Attachment 2
NRC3-13-0015
(2 pages)

Supplemental Response to RAI Letter No. 82
(eRAI Tracking No. 6975)

**Attachment 3
NRC3-13-0015
(3 pages)**

**Supplemental Response to RAI Letter No. 82
(eRAI Tracking No. 6976)**

Figure 3.7.1-204 **Randomized Shear Wave Velocity Profiles 1-30 for the Intermediate
Range Site Response Analysis Profile**
[EF3 COL 2.0-27-A, EF3 SUP 3.7-1]

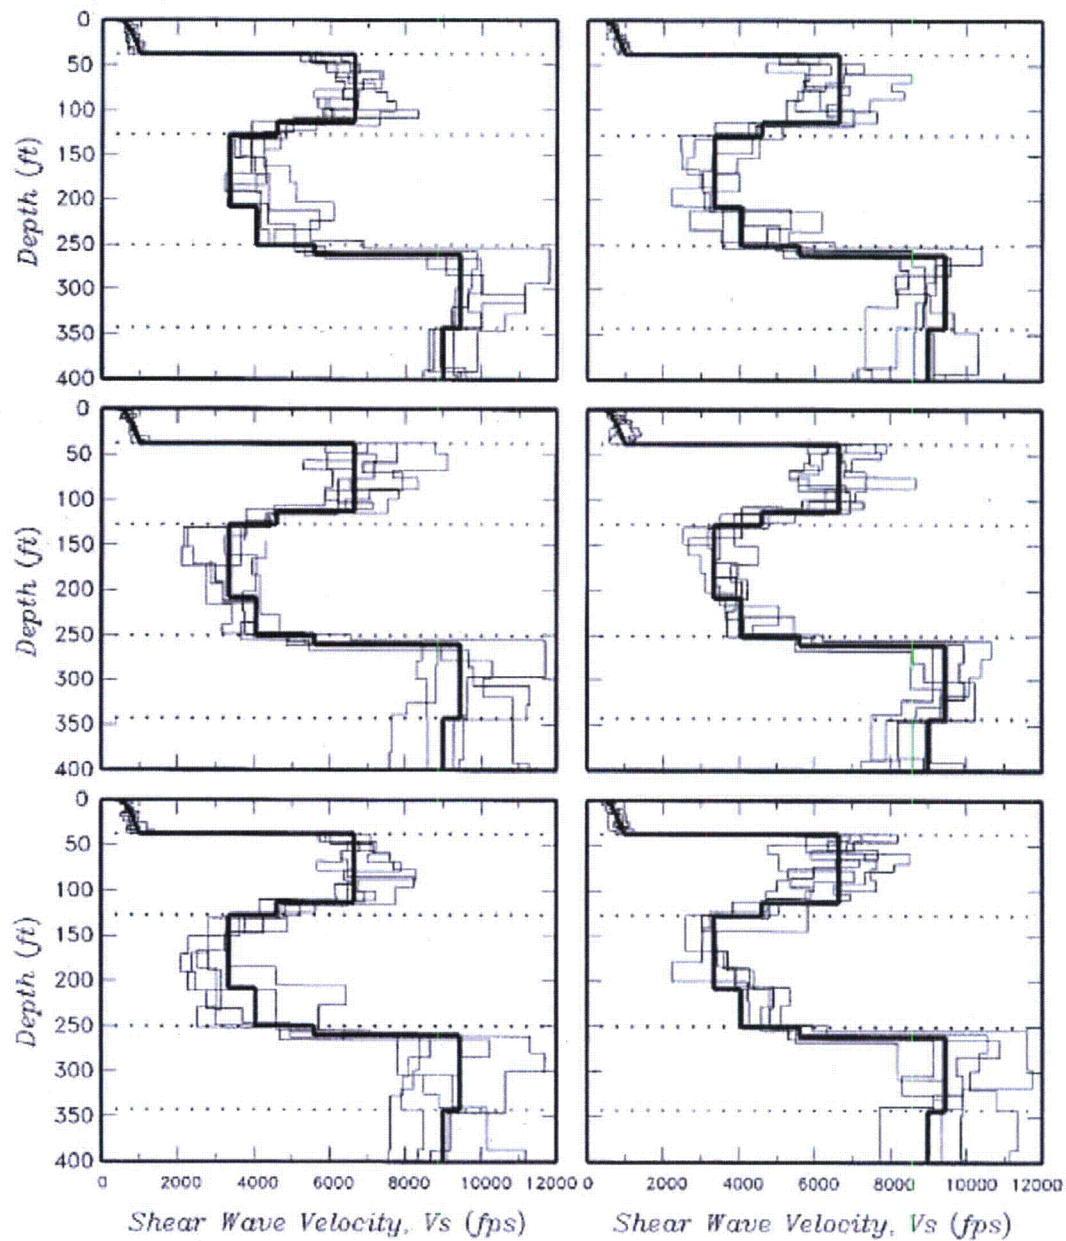
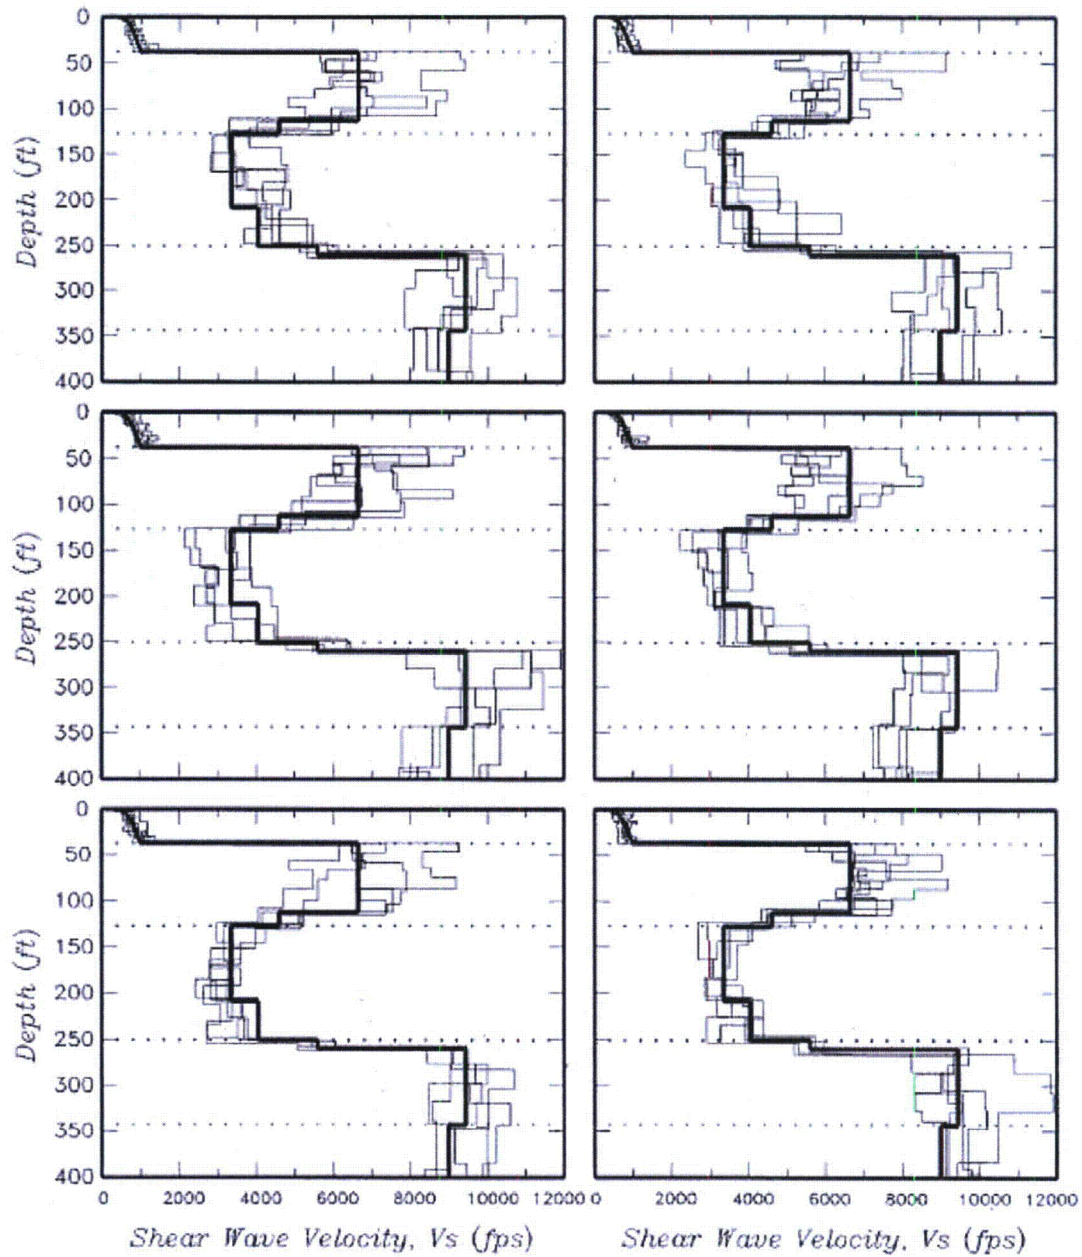
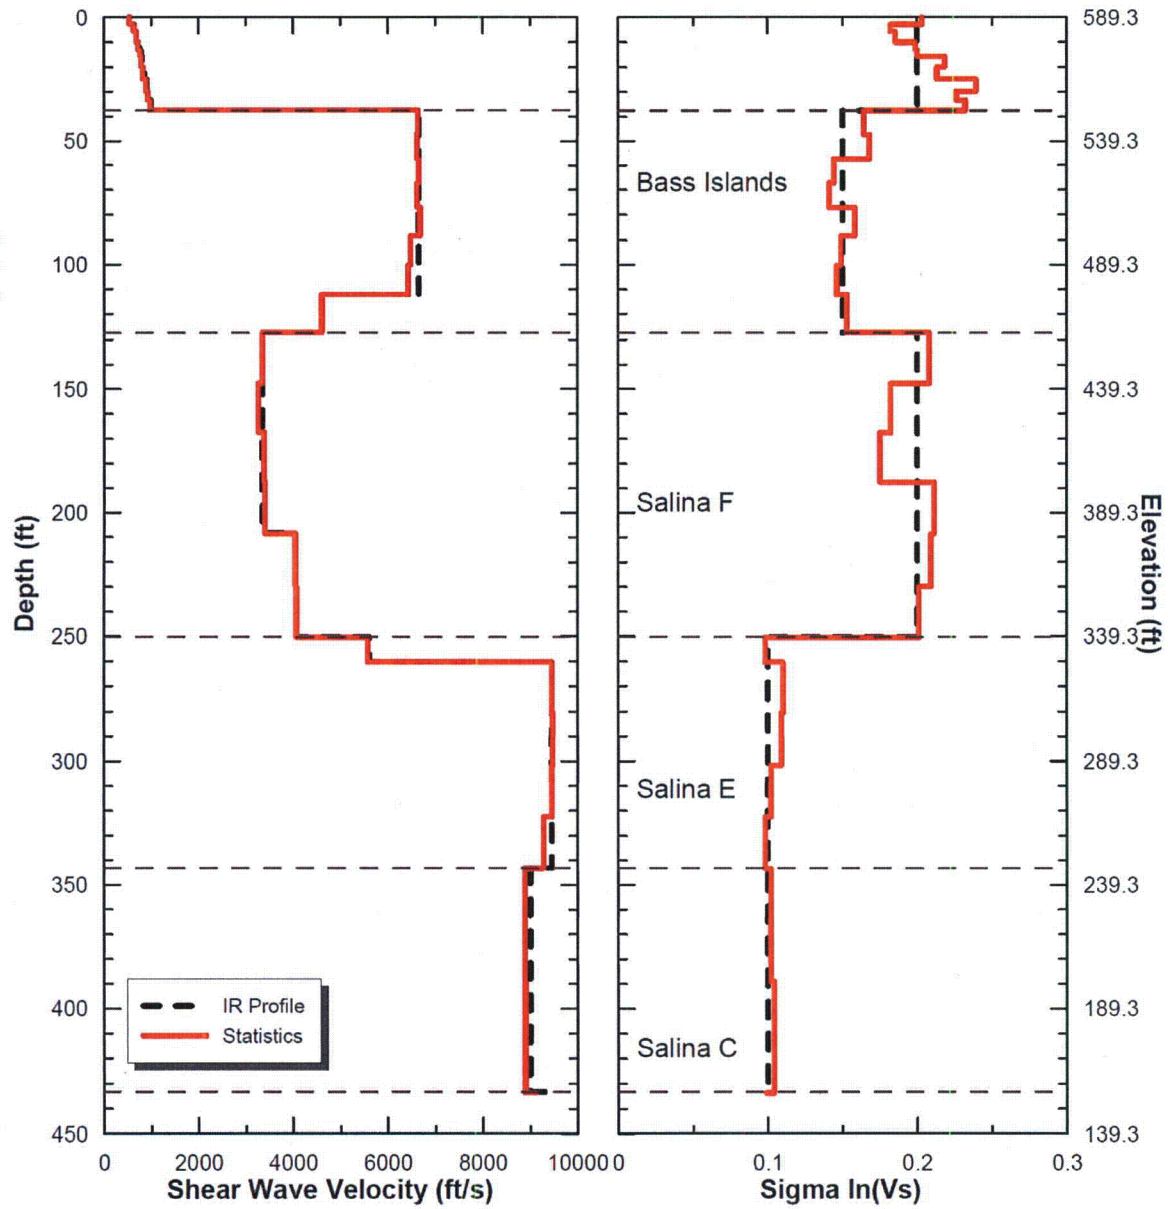
- a) FSAR Section 3.7.1.1.4.1.1 states that the shear-wave velocity for the granular backfill is estimated based on empirical relationships for angular-grained material from Richart et al. (1970). Please provide the range of parameters (i.e., void ratio and average effective confining pressure) that were used to define the lower range (LR), intermediate range (IR) and upper range (UR) shear-wave velocity profiles and explain why they are appropriate for the backfill material to be used at the site. Furthermore, please justify the use of Richart et al. (1970) in light of more recently published empirical relationships, e.g. Menq (2003), and include a discussion of the potential applicability of the more recent relationships.

The range of parameters used to define the engineered granular backfill lower range (LR), intermediate range (IR), and upper range (UR) shear wave velocity profiles are selected to represent the possible range of properties based on the anticipated engineered granular backfill types described in Fermi 3 FSAR Subsection 2.5.4.5.1. Subsection 3.7.1.1.4.1.1 of the markup for Fermi 3 FSAR Subsection 3.7.1 provides the detailed supplemental response regarding the range of parameters considered in the development of the LR, IR, and UR shear wave velocity profiles.

**Figure 3.7.1-207 Randomized Shear Modulus Reduction and Damping Relationships
Used for LR Engineered Granular Backfill Material
[EF3 COL 2.0-27-A, EF3 SUP 3.7-1]**

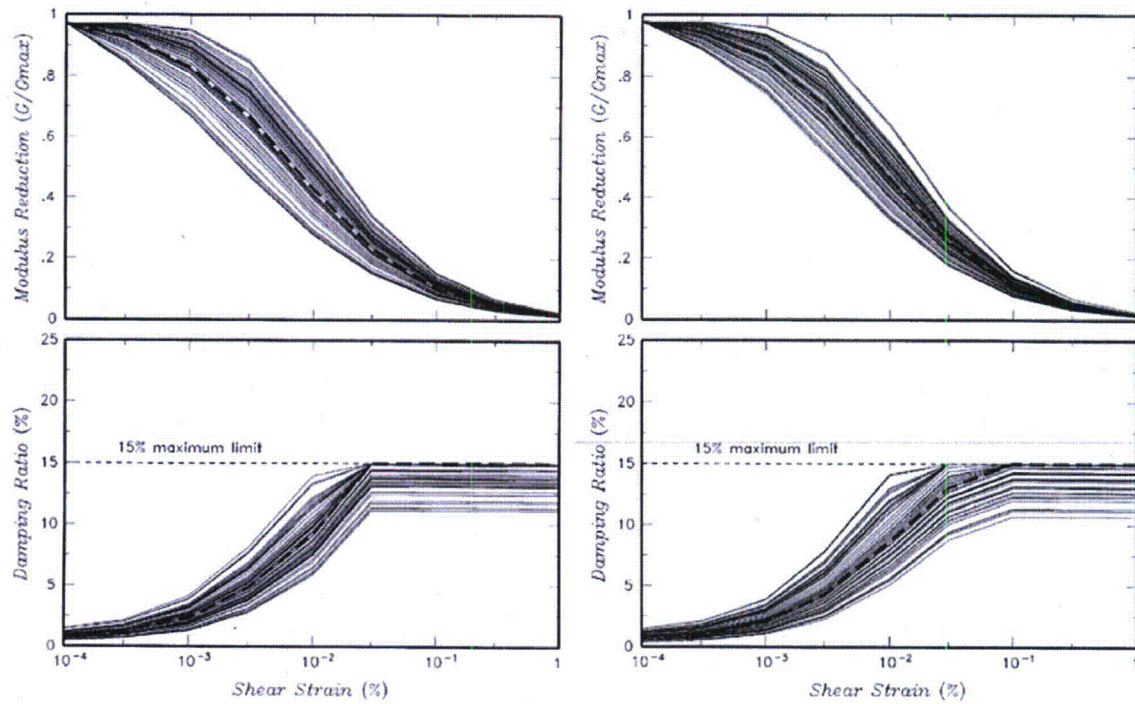
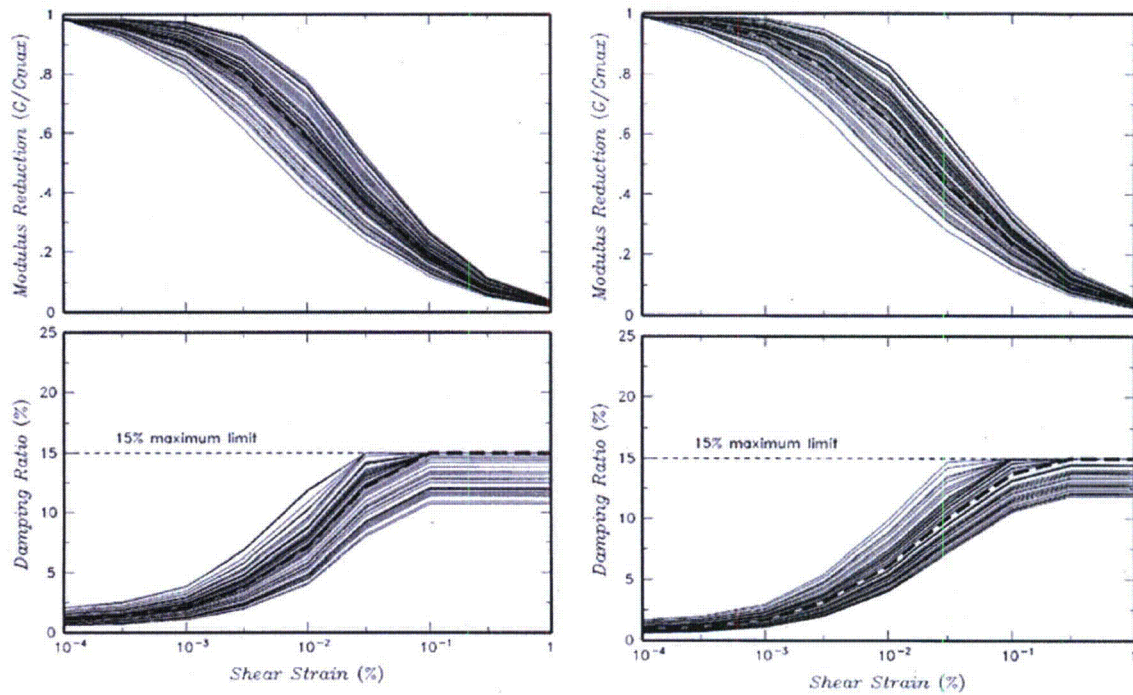
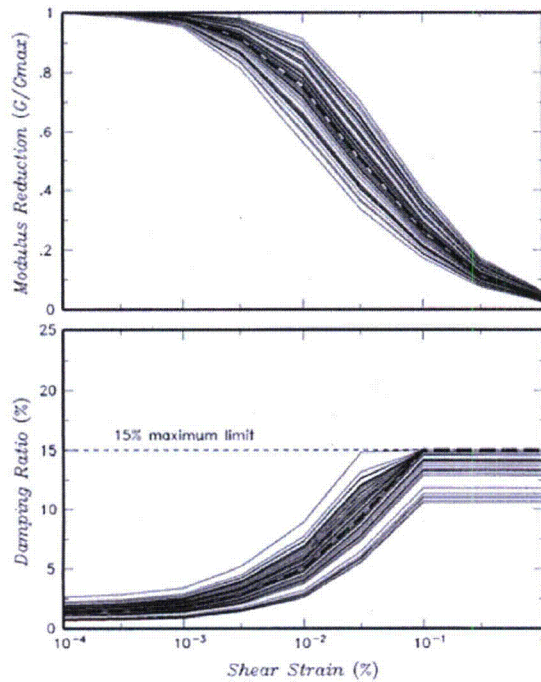
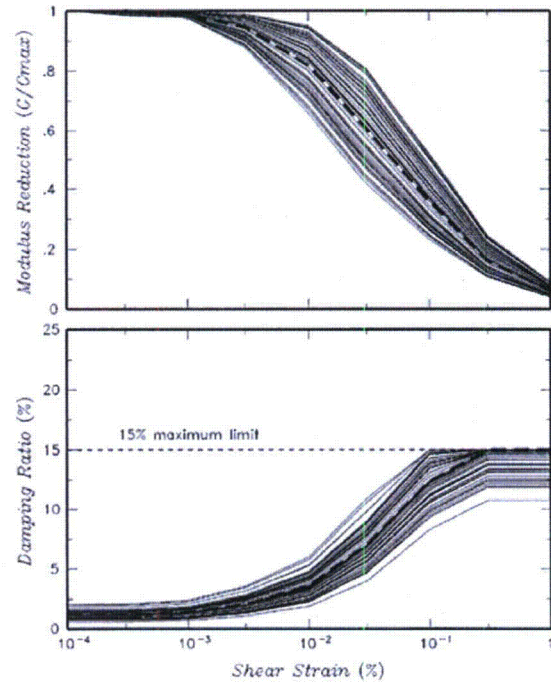
- b) FSAR Section 3.7.1.1.4.1.1.2 states that the shear modulus reduction and damping relationships selected for the granular backfill correspond to generic sand curves from EPRI (1993). Please justify the use of the EPRI (1993) generic sand curves rather than more recently published shear modulus reduction and damping relationships, e.g. Darendeli (2001) and Menq (2003), which may be more representative of the proposed backfill material. In addition, include a discussion of the potential applicability of the more recent relationships.

Subsection 3.7.1.1.4.1.1.2 of the markup for Fermi 3 FSAR Subsection 3.7.1 provides the detailed supplemental response regarding the development of the shear modulus reduction and damping relationships used in conjunction with the LR, IR, and UR shear wave velocity profiles.

Figure 3.7.1-222 **Deterministic Shear Wave Velocity Profiles for the Full Soil Column with Engineered Granular Backfill Above the Top of the Bass Islands Group Bedrock**

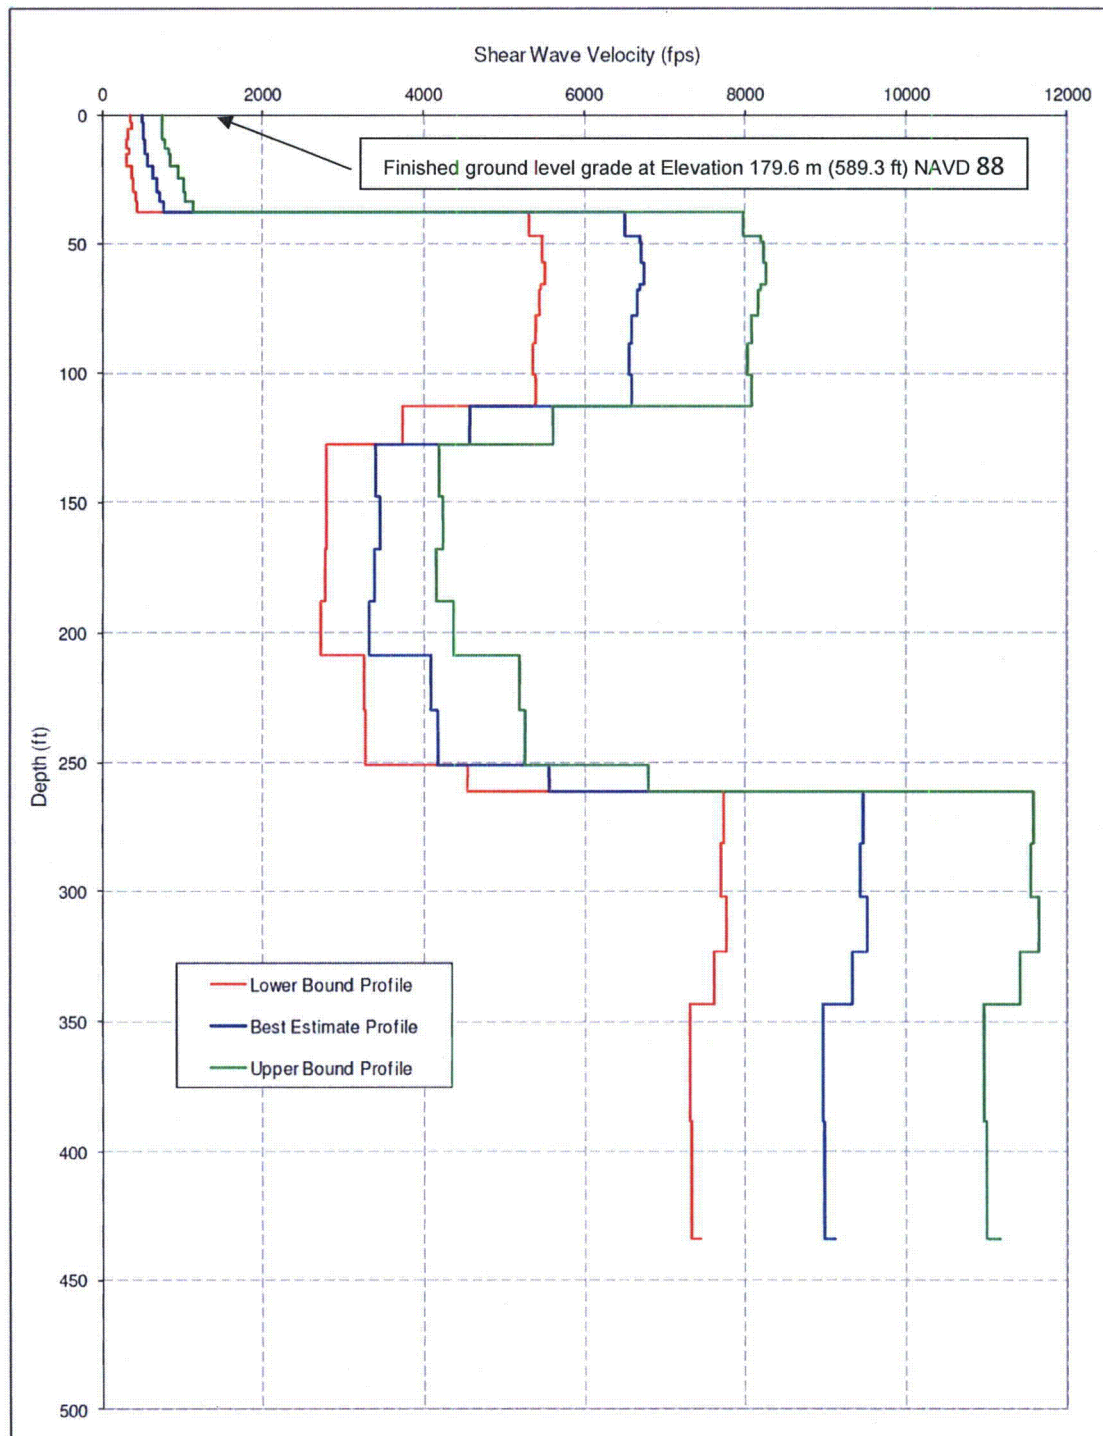
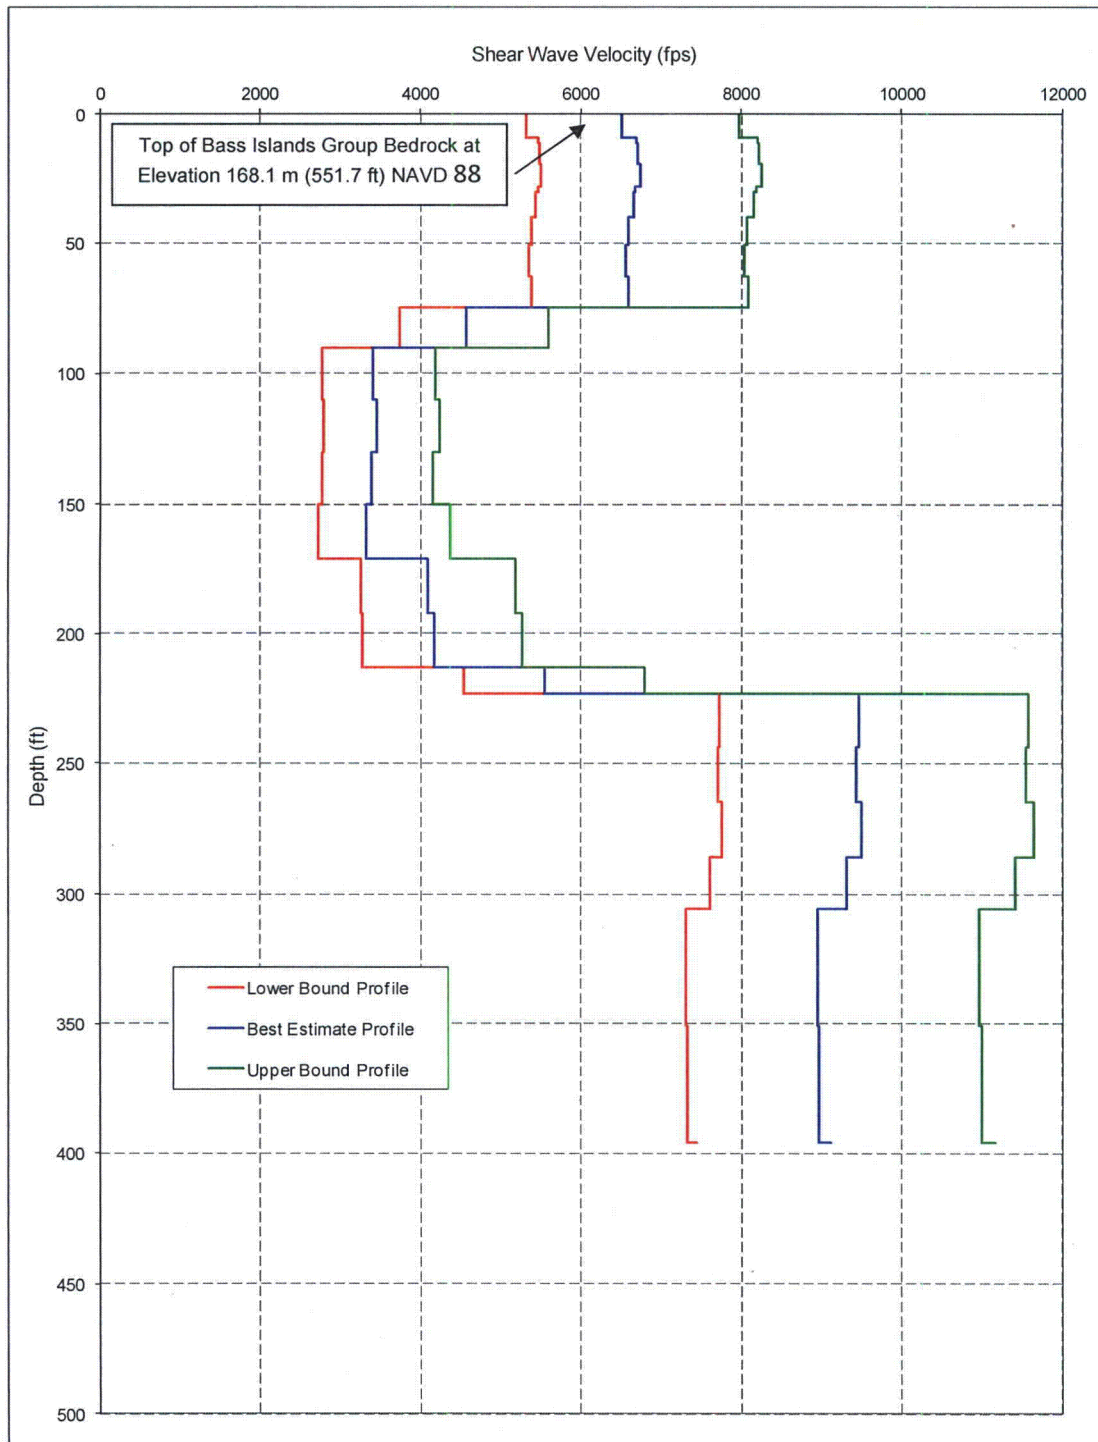
Fermi 3 FSAR Tier 2 Rev. 4 Section 3.7.1.1.4.4.3 describes the deterministic strain-iterated lower-bound (LB), best-estimate (BE), and upper-bound (UB) shear wave velocity profiles for the full soil column, which are used as input to the SSI analysis in accordance with SRP 3.7.2. These profiles are listed in FSAR Tables 3.7.1-205, 3.7.1-206, and 3.7.1-207, and shown in FSAR Figure 3.7.1-225. The FSAR indicates that UB and LB profiles were modified where necessary to maintain the minimum variation relative to the BE profile, such that $G_{UB} \geq 1.5 \times G_{BE}$ or $G_{LB} \leq G_{BE} / 1.5$ is satisfied as required by SRP 3.7.2. The staff notes that the value 1.5 (corresponding to COV=50%) is applicable to subsurface site conditions that have been "well investigated" by the geotechnical investigation. Since the engineered granular backfill above the bedrock has not yet been built, the applicant is requested to provide the technical basis for using COV=50% and not considering a minimum COV=100% for the backfill portion of the LB and UB profiles.

The initial response to this RAI was provided in DTE Electric Company letter NRC3-13-0007, dated February 8, 2013 (ML13043A012). As discussed in the initial response, a minimum coefficient of variation (COV) of 100 percent is applied to the engineered granular backfill in the lower bound (LB) and upper bound (UB) subsurface profiles. A minimum COV of 50 percent is used for the well investigated in-situ bedrock units beneath the engineered granular backfill. The use of these minimum COV values satisfies the requirements of Standard Review Plan (SRP) 3.7.2.

Subsection 3.7.1.1.4.3.3 of the markup for Fermi 3 FSAR Subsection 3.7.1 describes the development of the best estimate (BE), LB, and UB deterministic profiles for soil-structure interaction (SSI) analysis. Table 3.7.1-206, Table 3.7.1-207, and Table 3.7.1-208 of the markup for Fermi 3 FSAR Subsection 3.7.1 provide the BE, LB, and UB deterministic profiles for the Fermi 3 site with engineered granular backfill above the top of the Bass Islands Group bedrock.
